TITLE: VERIFICATION OF ANCHORAGE FOR PANEL 3-25-31 TO RESOLVE THE OUTLIER IDENTIFIED BY USI A46 EVALUATION (SSEL #39204).				PLANT/UNIT: BFN/3
PREPARING ORGANIZATION SITE ENGINEERING - CIVIL		KEY NOUNS (Consult RIMS DESCRIPTOR LIST) SEISMIC QUAL. EQPT. PANELS		
BRANCH/PROJECT IDENTIFIERS CD-Q3071-960089		Each time these calculations are issued, preparers must ensure that the original (R0) RIMS accession number is filled in. REV (for RIMS use) RIMS accession number		
		R ₀	R14 960807 104	
APPLICABLE DESIGN DOCUMENT(S) BFN-50-C-7100		R ₁	(A)	
		R ₂		
SAR SECTION(S) N/A	UNID SYSTEM(S) 071	R ₃		
REVISION 0	R ₄	R ₅	R ₆	Safety-related? Yes <input checked="" type="checkbox"/> No <input type="checkbox"/>
DCN No. (or indicate Not Applicable) T39817A				Statement of Problem:
Prepared: S. S. HAIDER <i>Syed S. Haider</i>				VERIFY ANCHORAGE ADEQUACY FOR PANEL 3-25-31 TO RESOLVE THE OUTLIER IDENTIFIED BY USI A46 AS NOTED IN SSEL # 39204. <div style="border: 2px solid black; padding: 5px; text-align: center; font-weight: bold; font-size: 1.2em;">ORIGINAL</div> LEGIBILITY EVALUATED and ACCEPTED for issue. <i>JR Glass</i> 8/6/96 Signature Date

THIS CALCULATION DOCUMENTS THE ADEQUACY OF ANCHORAGE

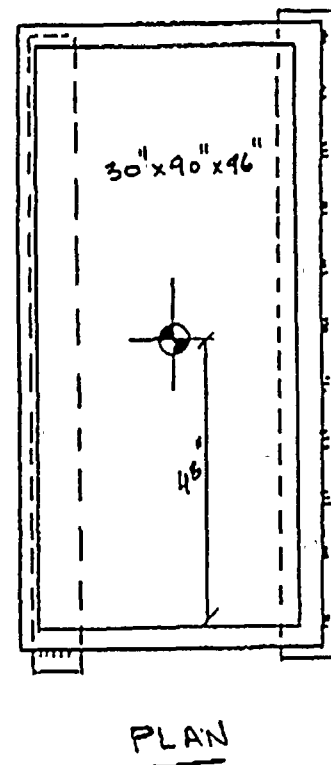
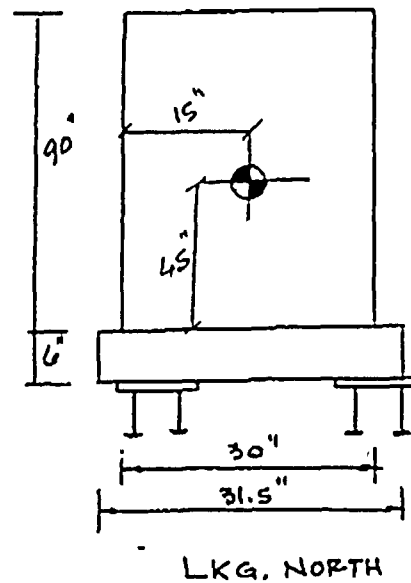
CRITICAL CASE : FORCE TOWARDS EAST

CONSERVATIVELY CONSIDER C.G. OF PANEL AS SHOWN ON SKETCH AT RIGHT.

$$\text{CAPACITY OF } \frac{3}{16} \text{ FILLET WELD} = \frac{3}{16} \times 0.4 \times 36 = 2.7 \text{ k}$$

$$\text{I.R.} = 2.95 / 2.7 = 1.09 < 10\% \text{ OVER DESIGN ALLOWABLE.}$$

IT IS ACCEPTABLE BASED ON SEVERAL CONSERVATIVE ASSUMPTIONS MADE IN THE CALC.

Ellevation
 (See SEW's for SSEL 9074, for plan of the bay anchorage to the pedestal)

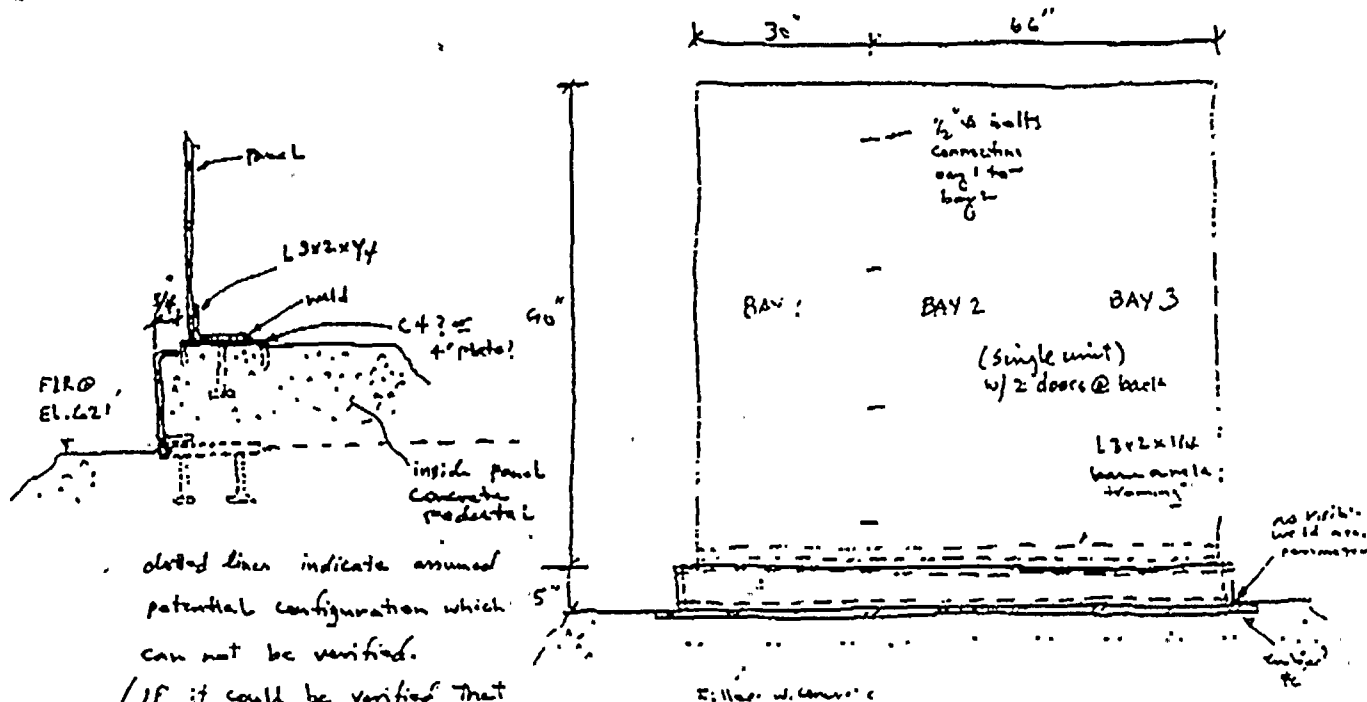
12) This panel is similar to panel 2-905-3 (SSEL 9074), except that it is not clear as to how the interior concrete pedestal, that this panel is sitting on, is connected to the floor (@ EL. 62'). [The Unit 2 panel's pedestal has a 1.5" channel that is welded to an embed plate.] The connection of the panel to the metal framing around the pedestal (sill channel) is adequate by comparison to panel 2-905-3. Since the overall anchorage scheme of the panel's pedestal to the concrete floor or the embed plate in the floor can not be verified, this panel is called an outlier SSEL-39204 w.r.t. its anchorage.

dotted lines indicate assumed potential configuration which can not be verified.
 (If it could be verified that the pedestal is anchored to the floor by dowels/rebars then the anchorage config. of this panel is adequate.)
